# Electronic Pressure Relief Valve (EPRV) Delete & Fuel Rail Pressure Sensor Update

Section Function Group 237

Model Years	Models
2018 - 2019	AN, CHU, CXU, GR, GI, PI MRU, LR, TE

Mack Trucks has identified through Remote Diagnostics that the vehicles in this Service Campaign have experienced faults with the Electronic Pressure Relief Valve (EPRV). To address this issue follow the repair outlined within this bulletin to remove the EPRV, inspect the Fuel Rail Pressure Sensor (FRPS) and wiring harness, followed by running an accessory kit to reprogram the vehicle.

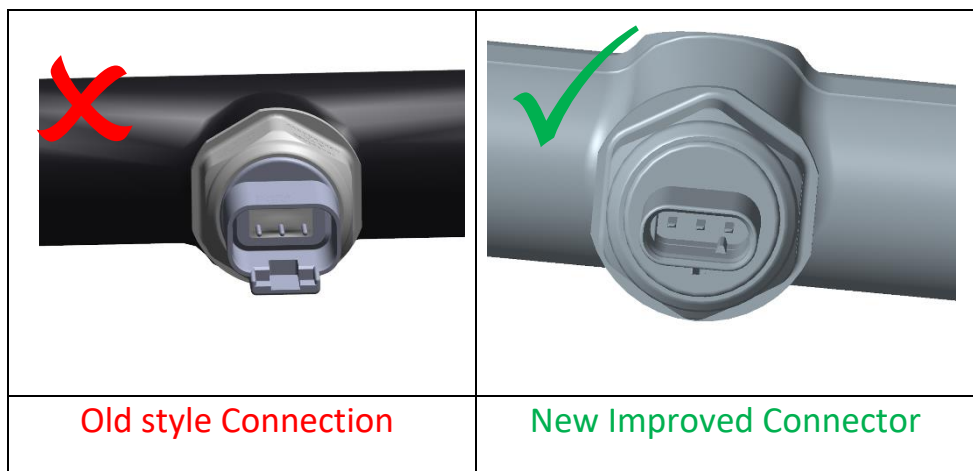
- 17. A product improvement has been made to the Fuel Rail Pressure Sensor (FRPS) and its wiring harness. A visual inspection of the FRPS electrical connector will indicate which sensor and wiring harness is on the vehicle

18. Inspect the FRPS, if the Old Style Connector is found (Displayed above with red X), replace the sensor and wiring harness per Impact Instructions listed below. If the New Improved Connector is found, no farther action is needed and proceed to next step.
  - a. 2373-03-03-06 Pressure Sensor, Common Rail, Replacement, Valve Cover Removed
  - b. 2861-03-03-03 Wiring Harness, Injector, Replacement (Rear), Valve Cover Removed
19. Refer to IMPACT document ID: 2115-03-02-02 *Valve Cover, Replacement* for valve cover install procedure.
20. Using PTT Operation 1700-22-03-06 Program accessory kit: **85156014**  
**Note:** Running this kit without removing the ePRV will result in adverse vehicle affects.
